The General Manager,
Northern Beaches Council
27 August 2020

Re: 129 Upper Clontarf Street Seaforth - DA 2020/0884

Proposed Alterations and additions - Construction of a Swimming Pool and ancillary works

View of Subject House from the rear yard of 127 Clontarf Street highlighting Building Bulk and overshadowing

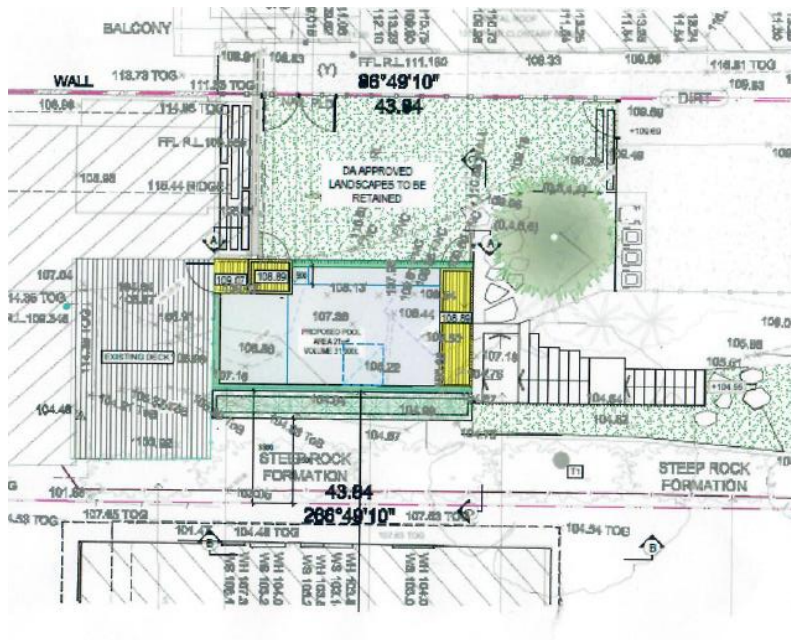
No 127 Clontarf Street is situated on the southern side and sits directly below the subject property. The subject property effectively towers over the adjoining southern property (see photo below).

Overshadowing and building bulk are present issues for 127 Clontarf Street.

Proposed pool showing proximity to neighbouring property. It is located above the roofline of 127 Clontarf Street with a setback of approx. 3m.

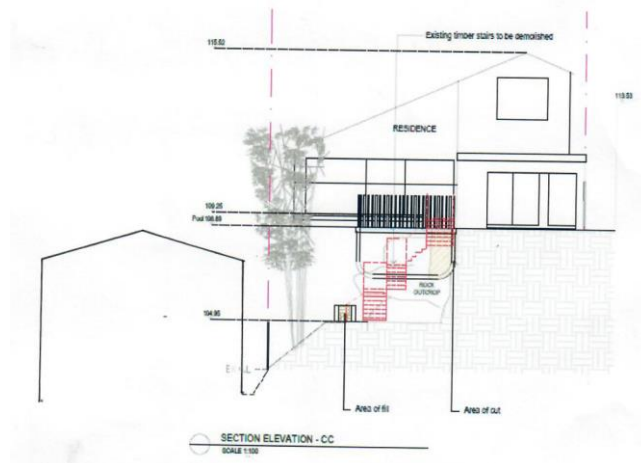
The proposed pool is to be built above an existing outcrop with a maximum height to the coping of approximately 4.5m at a setback from the southern side boundary of 3m. The access stairs to the pool deck and proposed retaining walls are also located near the southern side boundary.

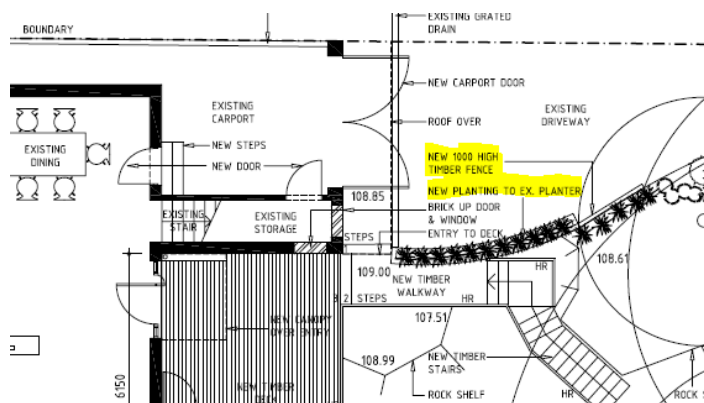
Presently the adjoining southern property benefits from solar access penetration. It is evident that the construction of the pool in its proposed location at an equivalent height to the ridge of the adjoining southern property will erode the remaining quality solar access available to the adjoining southern property.

Currently, there is sunlight entering all the first-floor windows from Spring through to Summer and into Autumn. The second-floor windows also get sunlight all year round. Should this proposal be approved, the lower kitchen and bathroom windows will lose direct sunlight all year round. The second-floor windows will also receive significantly reduced sunlight.

View of the location of the proposed Pool and surrounding Deck showing the proximity and height above the southern adjoining property.

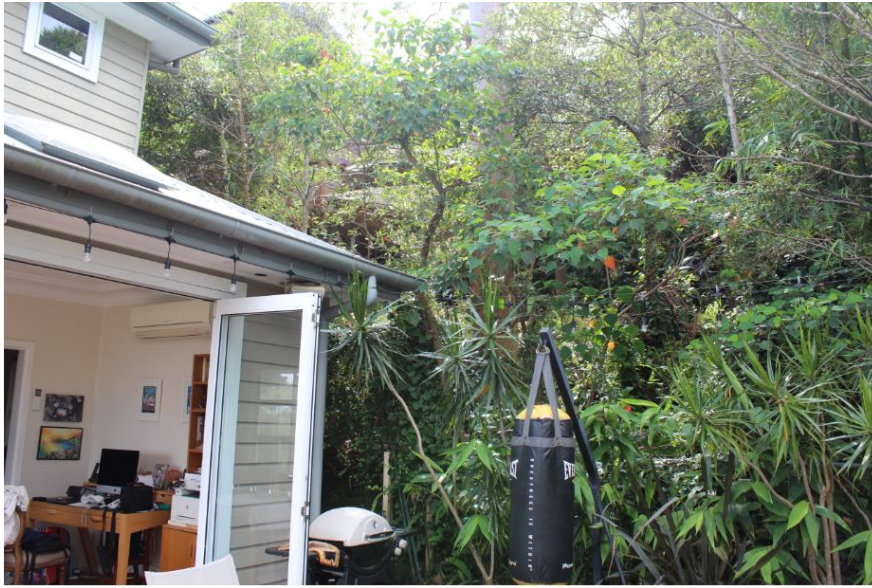
The applicant's commentary on overshadowing is not an accurate account of site circumstances and is dismissive of the real issues affecting the southern neighbour.

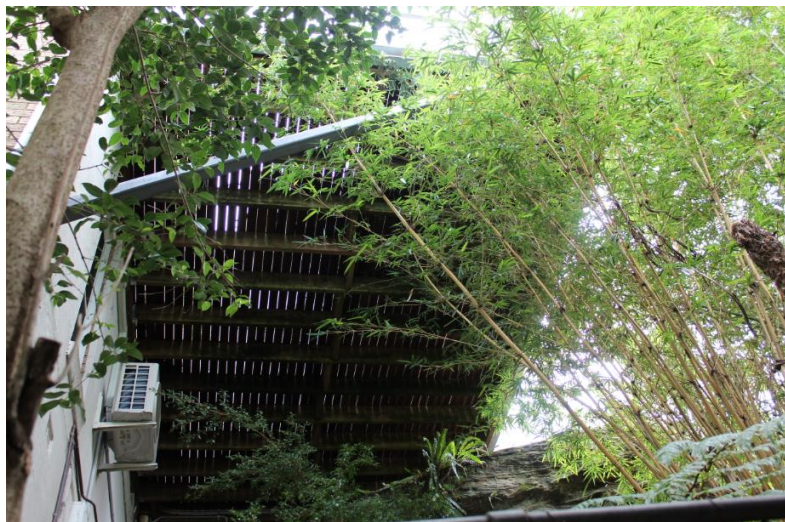
The proposal is not in line with preserving the natural landscape. This area of Seaforth is unique and any destruction of natural rock face should be avoided. The area is characterised by open spaces, large front setbacks and a bushland feel. To allow a natural sandstone cliff face to be cut back to facilitate a pool will change the character of this part of Seaforth. The subject property was purchased understanding the uniqueness of the block.
